RESOLUTION COPPER PROJECT EIS

REVIEW OF NUMERICAL GROUNDWATER MODEL CONSTRUCTION AND APPROACH (MINING AND SUBSIDENCE AREA)

PROJECT NO.: 1704005.03
DOCUMENT NO.: (if applicable)

Re: Review of Numerical Groundwater Model Construction and Approach (Mining and Subsidence Area)

Figure 2. 10-Foot Drawdown Contour After 200 Years for No-Action Alternative

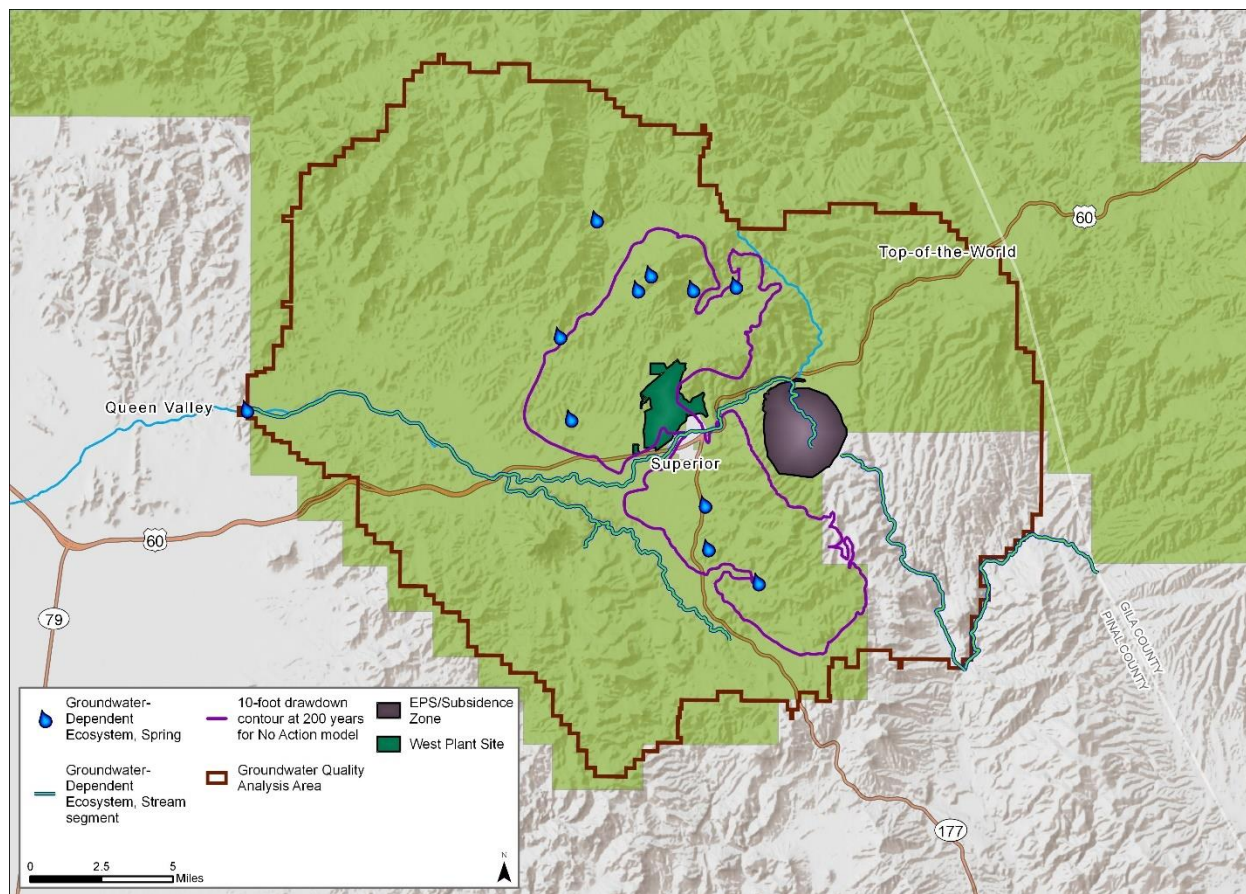
surface. At the end of mine life, dewatering would create a predicted drawdown of over 500 feet centered around old Magma mine workings. No additional drawdown was predicted in the Apache Leap Tuff in the area of Shaft 9&10 (the primary location of dewatering) because the Whitetail Conglomerate (Tw) aquitard that underlies the Apache Leap Tuff impedes upward propagation of drawdown. West of the Apache Leap escarpment, predicted drawdown continues to propagate in the Pz and pCy HGUs with the 10-ft drawdown contour reaching Bored Spring and Hidden Spring. Within the Gila Conglomerate (QTg) the predicted 10-ft drawdown extends to Walker Spring.

After 52 years, dewatering of Shafts 9 and 10 and the Magma workings would be discontinued, allowing water levels to recover. At 200 years into the future, 148 years after dewatering ends, the predicted 10-ft drawdown contour continues to expand slightly further than it was simulated at the end of mine life period. After 200 years, predicted water levels will have rebounded over 500 feet around the old Magma mine workings (**Error! Reference source not found.**).

Figure 3. 10-Foot Drawdown Contour After 200 Years for Proposed Action Alternative

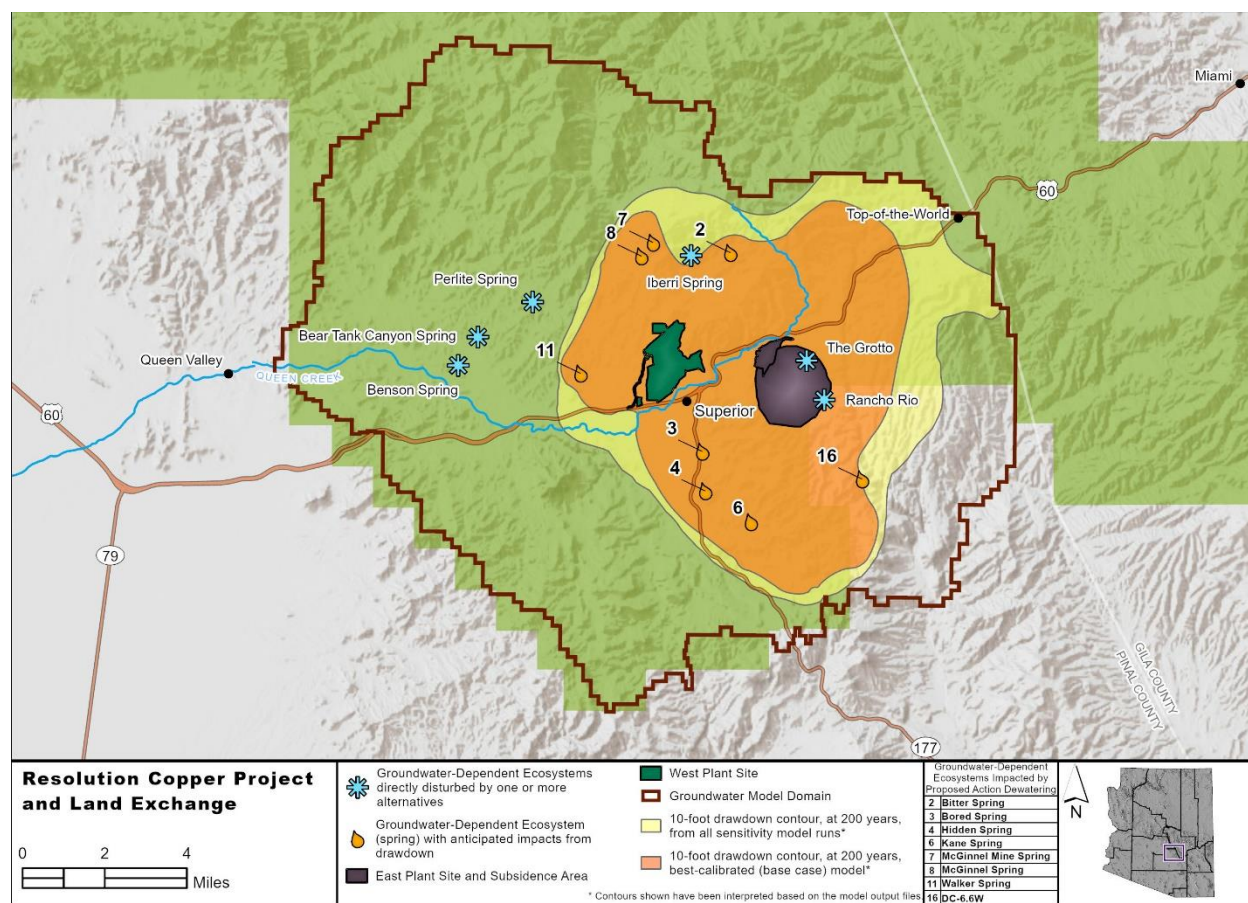
At 200 years into the future, 148 years after dewatering ends, the predicted extent of the 10-foot drawdown zone had continued to increase, as water was predicted to continue to flow towards the block cave zone. The predicted 10-foot drawdown zone extends up to five miles from the East Plant Site. This predicted drawdown zone includes nine GDEs and water supply wells with predicted impacts exceeding 10 feet (**Error! Reference source not found.**) [Bitter, Bored,

Hidden, McGinnel, McGinnel Mine, Walker, Kane, and DC-6.6W Springs, and well DHRES-16 representing wells in the Town of Superior]. However, six of these also had predicted drawdowns exceeding 10 ft under the No Action alternative. Hydrographs showing drawdowns for the GDEs indicate that the drawdown continues to increase after 200 years especially for GDEs to the south and the southeast of the East Plant Site. Detailed results are given in WSP (2018d).

The following is a key finding from the GWMG: *Predictions of drawdown are approximations of a complex physical system, inherently limited by the quality of input data and structural constraints imposed by the model grid and modeling approach. The groundwater model does not predict changes to flow magnitude and timing at a given GDE. By extension, drawdown contours do not represent the aerial extent of anticipated impacts to GDEs. These contours will be used to inform more site-specific impact monitoring and mitigation.*
